Planning Commission Meeting
Thursday, January 8, 2015
Meeting held at the Saratoga Springs City Offices
1307 North Commerce Drive, Suite 200, Saratoga Springs

**Concept Plan
VASA Fitness
January 8, 2014
Public Meeting**

Site Plan and Conditional Use Permit

VASA SARATOGA SITE PLAN

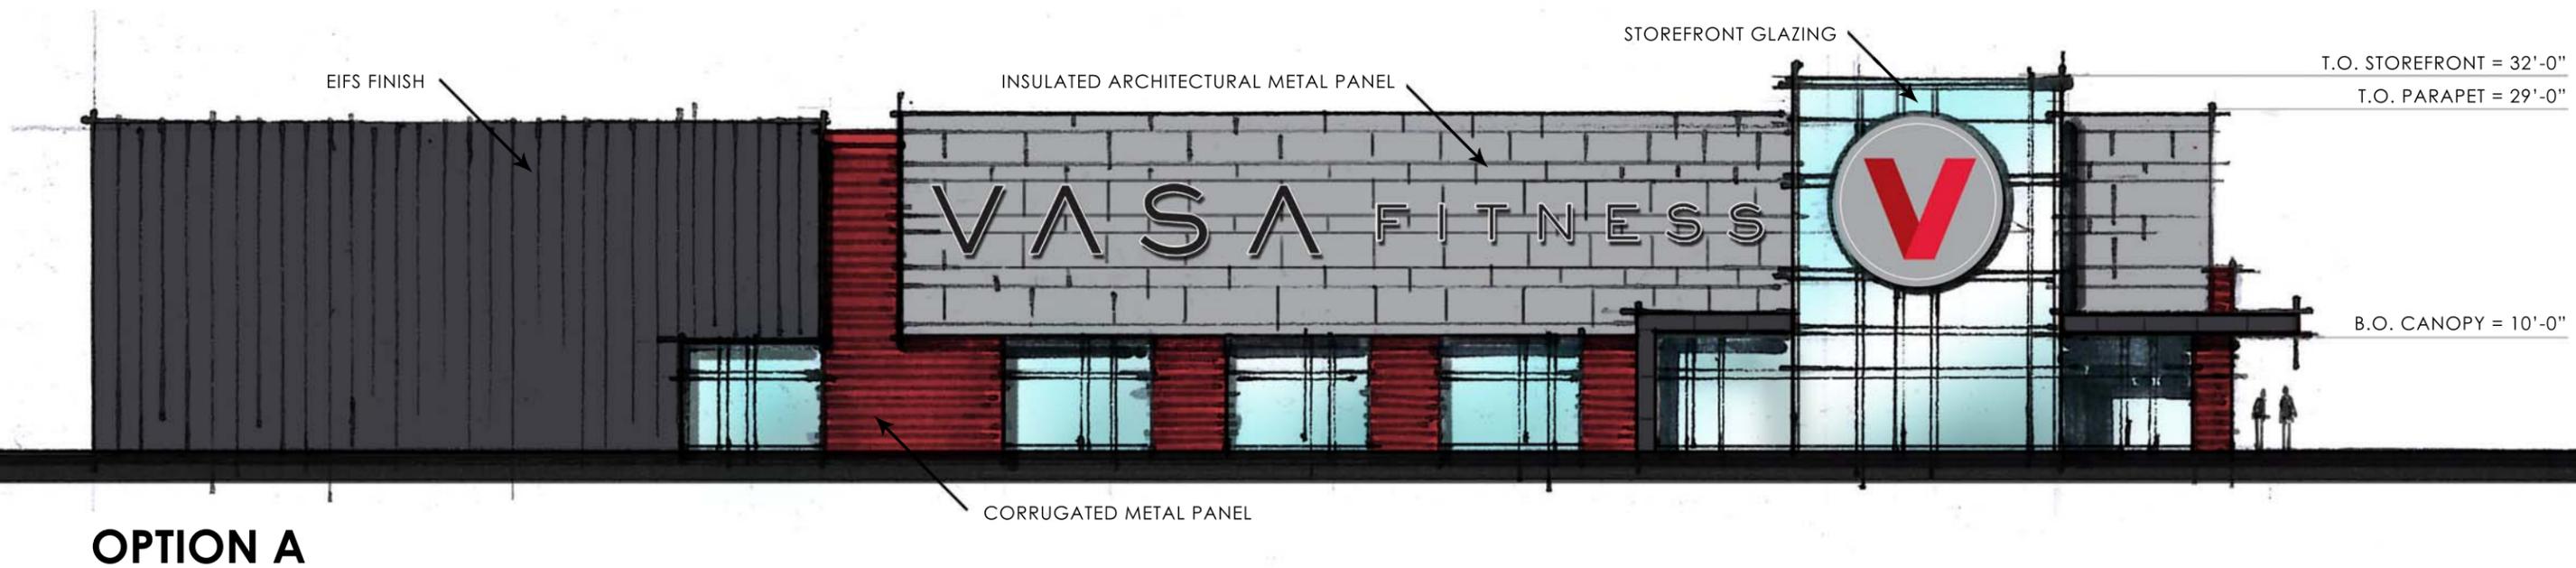
Landscaping Requirements: complies. Twenty percent of the total project area is required to be landscaped and all sensitive lands shall be protected. *The plans indicate 21.2% of the site will be landscaped. No sensitive lands have been identified within the project area.*

Parking: up for discussion. Section 19.09.11 requires specific numbers of parking stalls based on specific land uses and requires 6 stalls per 1000 square feet for fitness centers. *The concept plan indicates 5.3 parking stalls per 1000 square feet. The applicant has indicated that this requirement exceeds the requirements in other Cities and exceeds their needs based on typical use at their other sites and have submitted a request for a code amendment to reduce this requirement to 5 stalls per 1,000 square feet.*
